RE: MCPS2135, Power Amplifier system

The following modifications were made to our MCPS2135 power amplifier. These modifications were required to meet the radiated emissions requirements of FCC part 22.

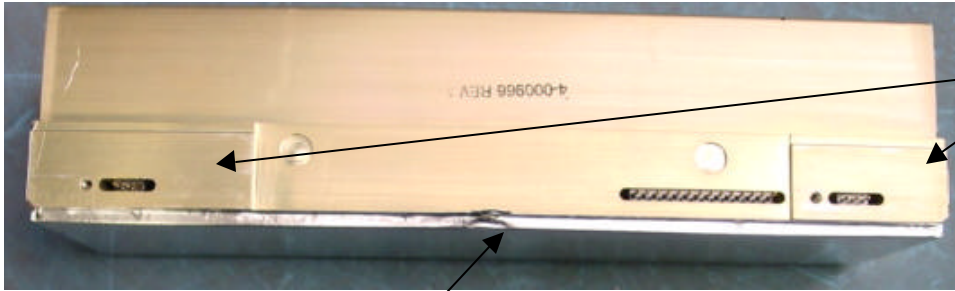
1. Aluminum tape was used to close the second slot opening in the PA module front panel.
2. RF absorber material was added to the backplane assembly (A4E) inside the MCPA modules.
3. Aluminum tape was wrapped around the cover of the A4 BPM Modules to improve their RF shielding.

The aluminum tape used for changes 1 and 3 is 3M Tape 1170, 3/8" wide

The RF absorber added to A4E assembly is: BSR-I/SS-6M

With each BPM removed from the assembly, apply aluminum tape around the edges of the cover on all four sides as shown below. 3/8" tape may be used on the front and sides, and 3/4" tape should be used along the back of the BPM. Be careful not to cover too much of the heatsink fin area. On the back edge of the cover, do not let the tape extend past the back edge of the top of the heatsink. The surface that mates with the backplane should be CLEAN and COMPLETELY FREE OF TAPE.

No tape on this surface

Tape edges as shown
